Product hierarchy no. *				Part no.	SBU	Type / Description	Customer part no.
SBU	PG	PUG	Type				
02	007	021	0000002433	See list below	Connector	2572 Appliance Inlet C8	n/a

UL upgrade from UL 498 to UL 60320-1.

Product Change Notification					2572 Change of marking		
owner	creation date	release date	released by	change order no	rev	page	D10-055-460
zeierjo	31.03.2021	31.03.2021	muehlema	2020484	B	1 of 2

Old product rating	New product rating
Terminals in orientation A Front side  Back side 	Terminals in orientation A Front side „S „ removed  Back side

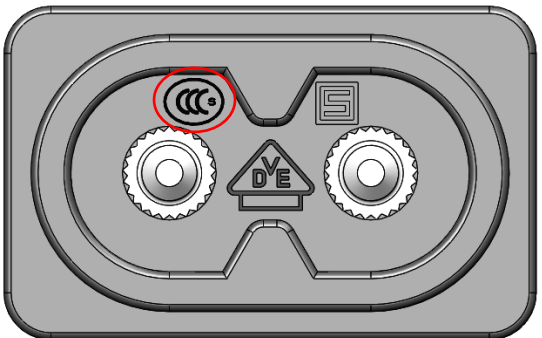
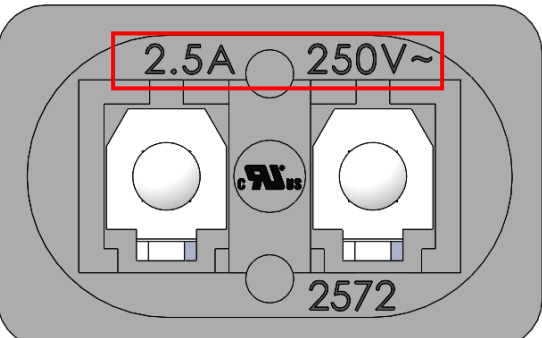
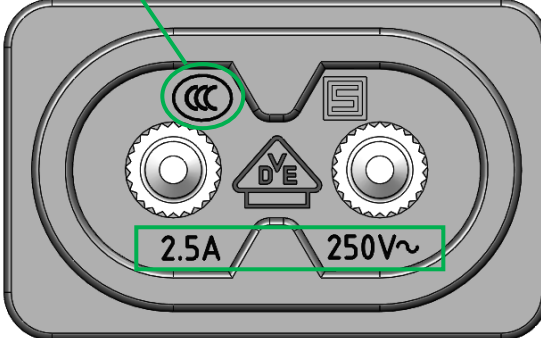
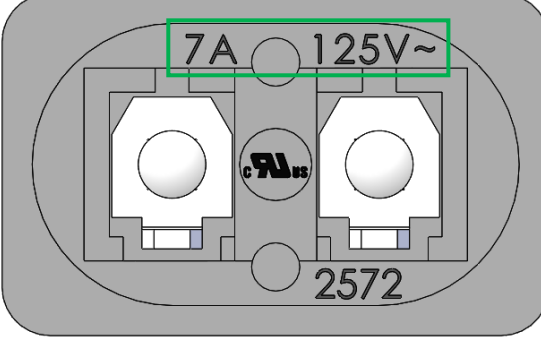
Marking for UL rating 7A/125V~ updated. Marking for IEC rating 2.5A/250V~ updated.

In the Chinese test mark CCC, the small S on the right of the third C has been removed.
